## RE: RMS BEACHES LINK (SSI-8862) – Submission in Objection

We refer to the Department of Planning, Industry and Environment (DPIE, and Department) public notification to the 'State Significant Infrastructure' (SSI) and 'Environmental Impact Statement' (EIS) for the Transport for NSW - Roads & Maritime Services (RMS, the Proponent) – Beaches Link and Gore Hill Freeway Connection project (the Project, SSI-8862).

Figure 9 EIS chapter 6 – Key plan and construction footprint

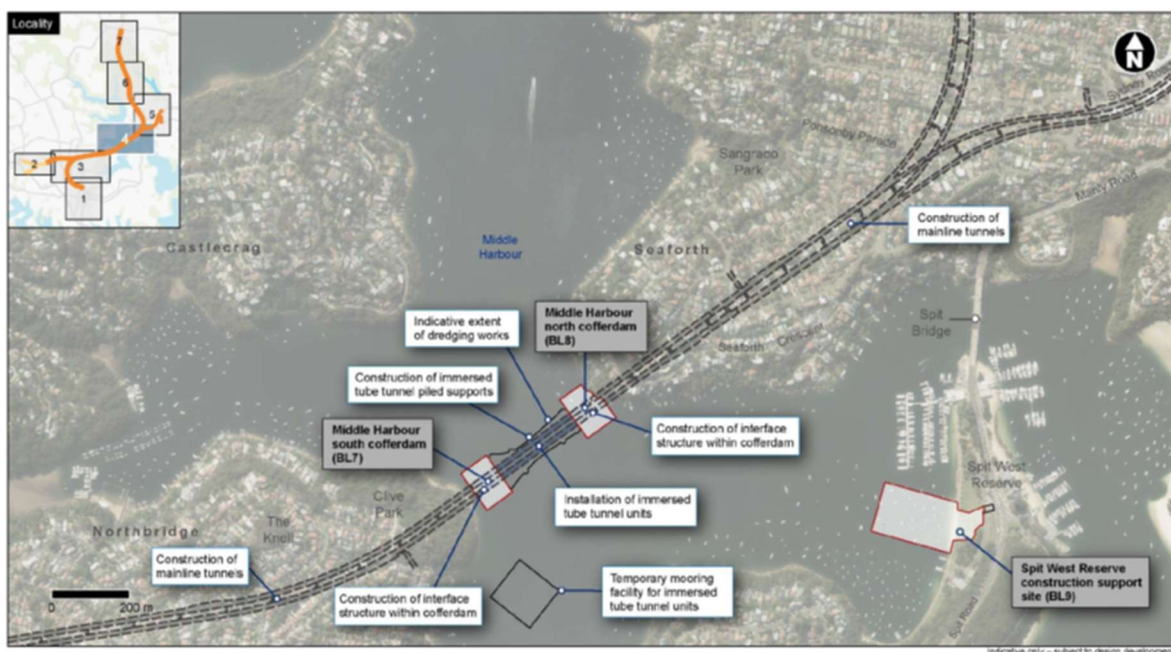
It can be seen from **Figure 9** and **Figure 10** that the location of the Proponents new harbour crossing, the construction zones, the restricted waterways, and the location of the temporary tunnel storage units and Spit West construction site, is in direct conflict with the Primary Boating Activity waterway area of Middle Harbour.

Figure 11 Harbour Crossing construction, overlaid with the 1<sup>st</sup> NB Boat Shed, J24 Mooring and Beauty Point canoe training area

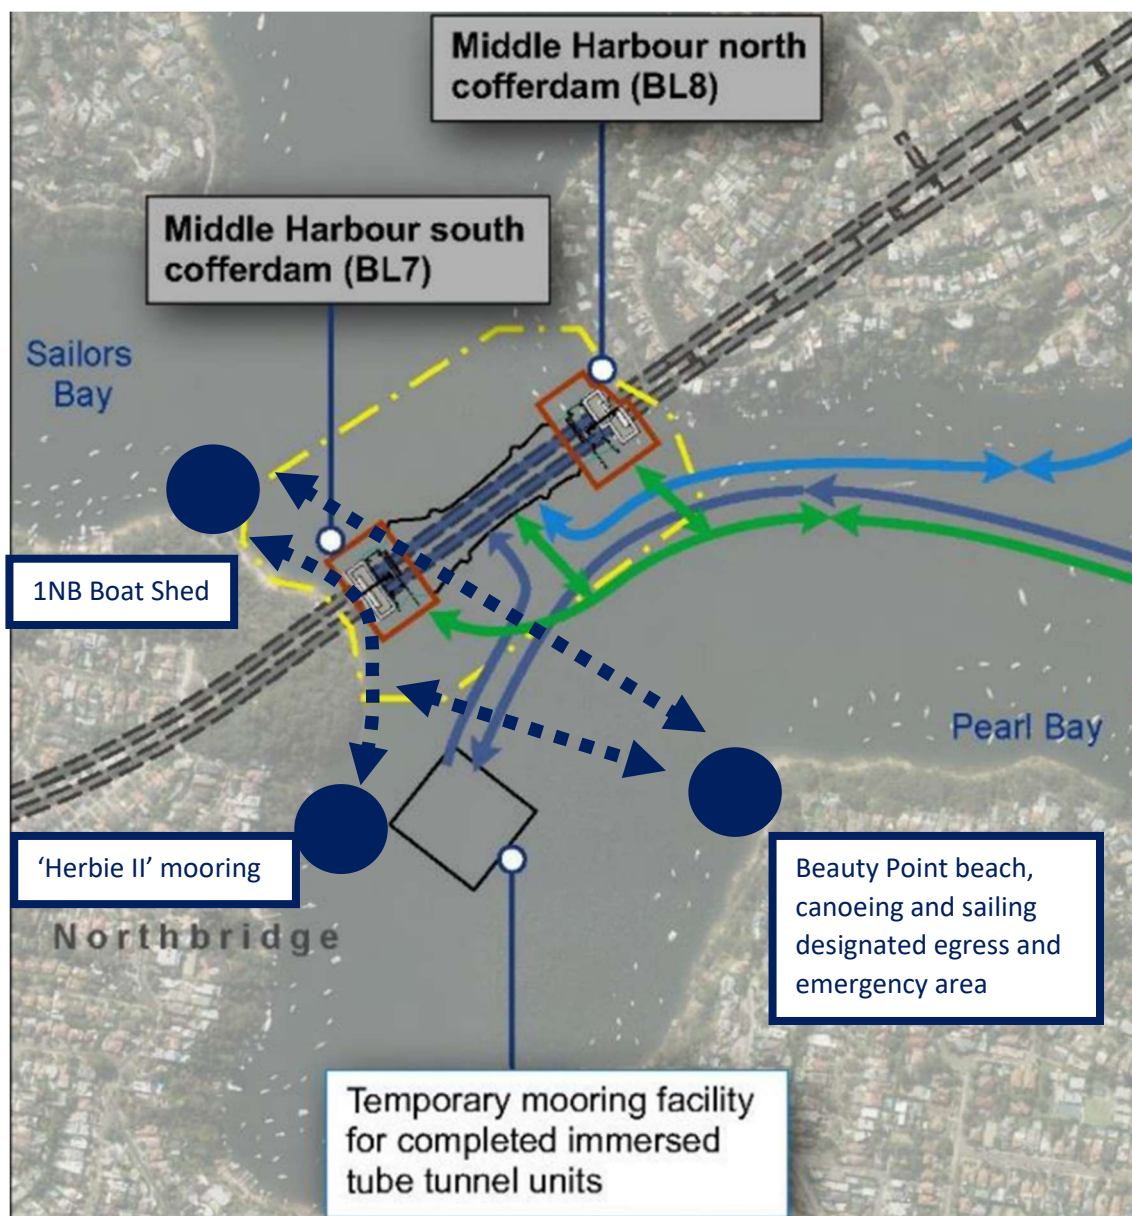
The tunnel construction and the location of the temporary tube mooring facility is in direct conflict with our current and preferred canoe training areas and our Primary Boating Activity areas, refer to **Figure 11** below:

Further, our 'Herbie II' (a J24 keeler) and its swing mooring location, is now effectively isolated (refer to **Figure 11**) from our Boat Shed. This boat is used for sail training and as a secondary safety boat. Herbie II is 'typically' sailed north from its mooring between 17:30-18:30hrs (most summer weeknights) to the central Middle Harbour area and then west to our Boat Shed and it is then returned to the swing mooring between 19:30 and 20:30hrs.

Our Scout Group Committee and Scout Leadership request that the Proponent relocate our J24 keeler to a new mooring (located within 200m of our Boat Shed) for the duration (or permanently) of the primary maritime works and for at least until 12 months post Substantial Completion of the works (to allow for works maintenance). If an existing mooring is not available, we request that the Proponent establish a new mooring and/or a piled-fixed/tandem mooring (at their cost) for the full duration of the pre-construction and primary maritime works.

Figure 12 EIS Appendix F – Traffic and Transport (Part 2) – Draft Construction Management Plan (with unconfirmed restrictions)

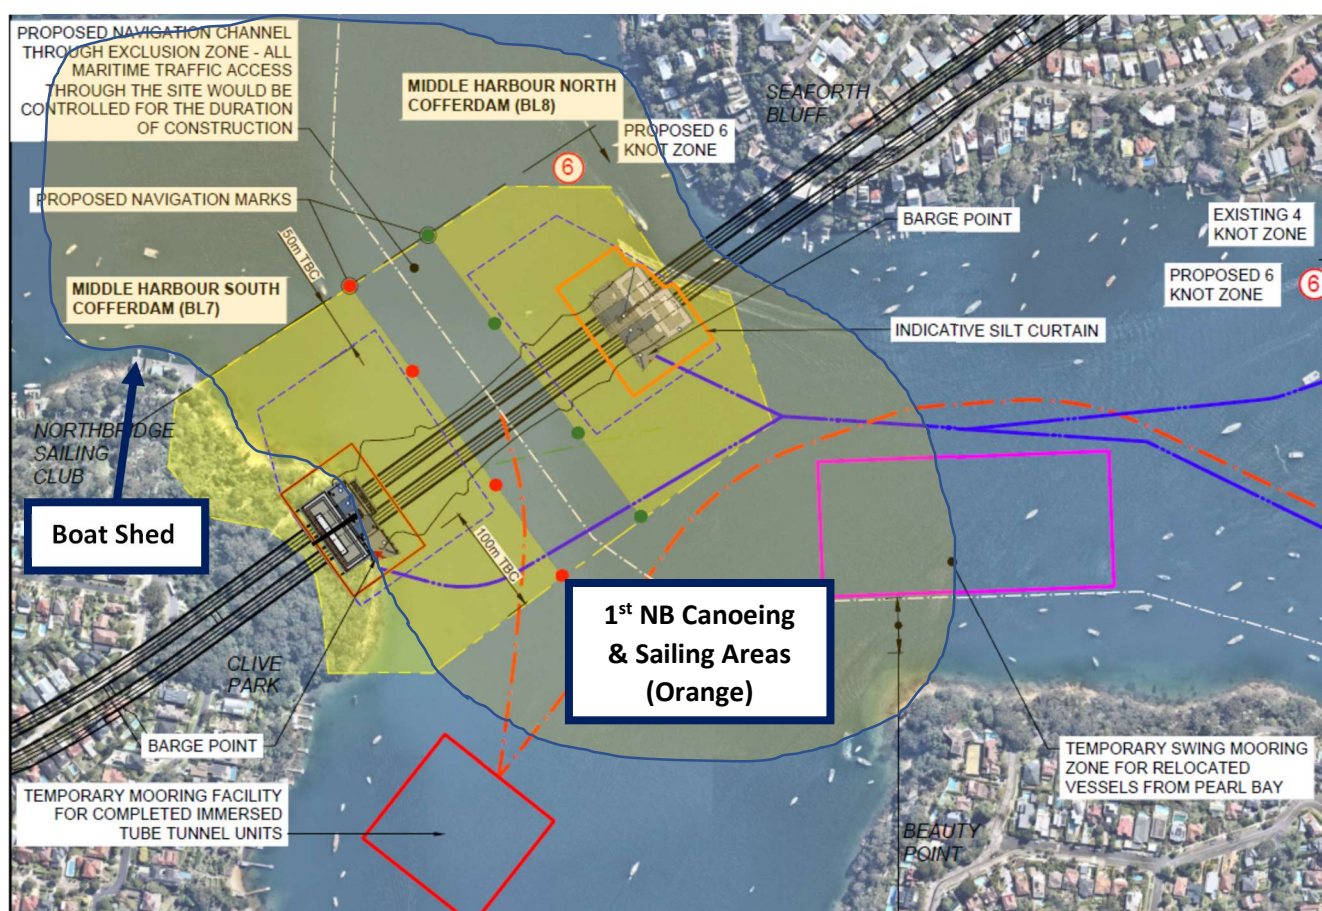
The proposed waterway restriction area (refer to **Figure 12**) poses significant risks and hazards to our normal Primary Boating Activity waterway operational area. The planning and location of the navigation markers, immersed tubes and coffer dam works have not been made in discussion with the local maritime users, the navigational impingements are not safe for canoeing and/or sailing vessels (i.e. non-powered vessels).

**Note: Another EIS documentation “error”,** the maritime construction site and coffer dam work area (BL7) are now shown within the Clive Park Heritage Area and overlay with the Aboriginal caves/shelter and artwork site locations.

Figure 13 EIS Chapter 17 and Appendix P - Hydrodynamic and dredge plume modelling (the 98<sup>th</sup> percentile would the wider fetching)

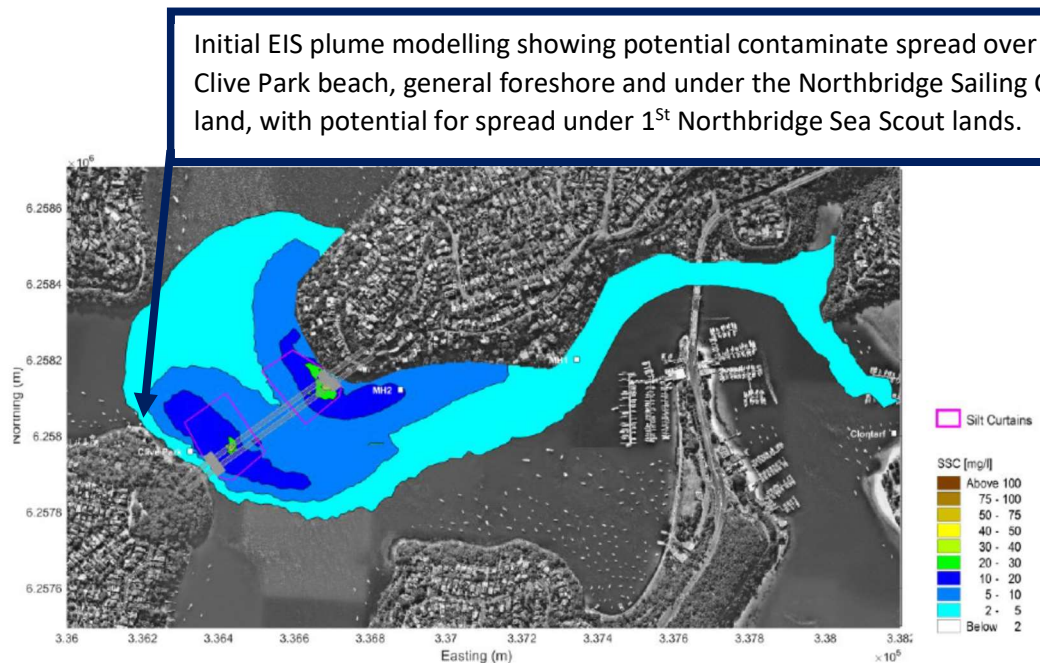
Initial EIS plume modelling showing potential contaminate spread over Clive Park beach, general foreshore and under the Northbridge Sailing Club land, with potential for spread under 1<sup>st</sup> Northbridge Sea Scout lands.

that a 98<sup>th</sup> percentile drift and sedimentation profile is adopted for human health risk assessment purposes, and that human health effects are tested as a primary outcome of the revised modelling.

Figure 16 App G Noise and Vibration – BL7 (Standard Hours), LAeq (15min) at 70-75dB(A) at the Northbridge Sailing and Boat Shed (Green)

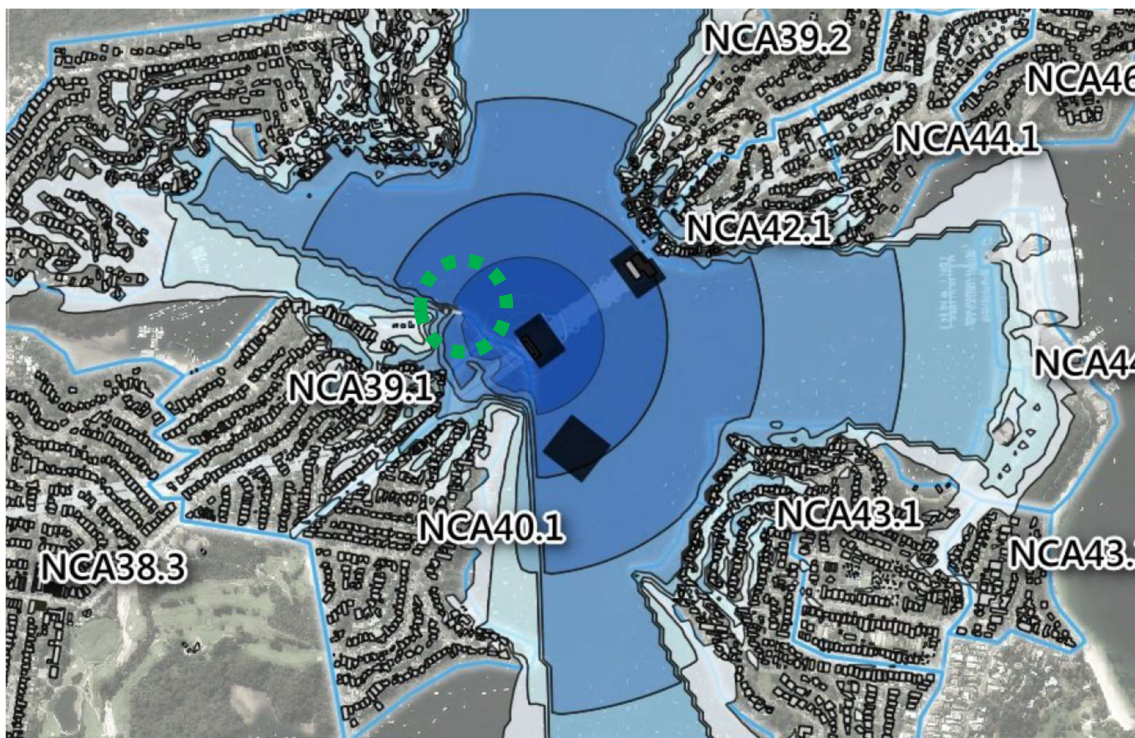
We dispute this positions, both the Northbridge Sailing Club rooms and 1<sup>st</sup> Northbridge Boat Shed (along with numerous residents in Northbridge and Seaforth) will be subjected to prolonged periods of construction noise between 70-75dB(A) as shown in **Figure 16**, extracted from the EIS.

This level of noise exposure is considered by the NSW Environmental Protection Authority (NSW EPA), as a **‘Highly Noisy’** environment (refer to **Figure 17**) and in our opinion, prolonged periods of exposure to this high level of construction noise can and will be damaging<sup>7</sup> to our young Scouts, to our canoeing and sailing groups, and to the local residential and to the public using Clive Park Heritage Area.

We fully expect that there will be long periods of disruptive maritime construction activity with high noise thresholds, and we will be seeking noise and vibration **respite and compensation** for loss of waterway use and loss of use of our Boat Shed activities, in accordance with the EPA Construction Noise Guidelines (refer to **Figure 18**) .

Figure 20 Beaches Link interactive portal overlaid with the Clive Park shelter/cave location (blue shaded and dashed line)

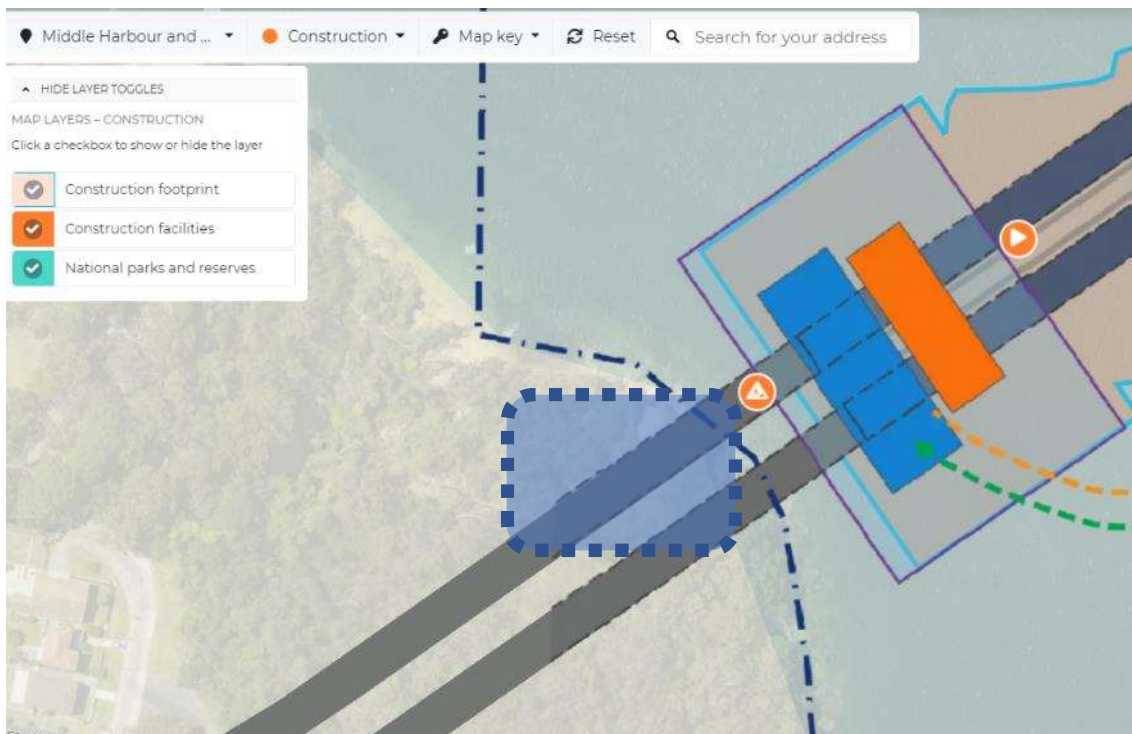
The north bound tunnel and associated rock bolting used with this type of construction, and based on the EIS tunnel and coffer dam sections/sketches (which are not detailed nor definitive), the rock bolts will probably be located within 10-15 metres and the tunnel crown at 15-20 metres to the bottom of the rock outcrop.

There is therefore high potential of Aboriginal shelter/cave site subsidence, high potential for significant damage to irreplaceable Aboriginal caves/shelters and to listed artworks, or in the **worst case full rock face collapse** and the risk/hazard to our young Scouts and to the public, who frequent this park area, due to the Proponents tunnelling and adjacent coffer dam works (refer to **Figure 20 and Figure 21**).

**(CPHA-02)** A detailed geotechnical, structural and vibration analysis is carried out prior to any excavation or land lowering or ground water lowering activity. The Proponent must undertake a geotechnical, structural and vibration analysis of the CPHA aboriginal and heritage listed cave/shelter structures and artwork rock faces, to determine the effects of the tunnel works and activities on those elements. The Proponent must provide regular updates on the maritime and CPHA activities to the Maritime Working Group and to the Secretary Planning.
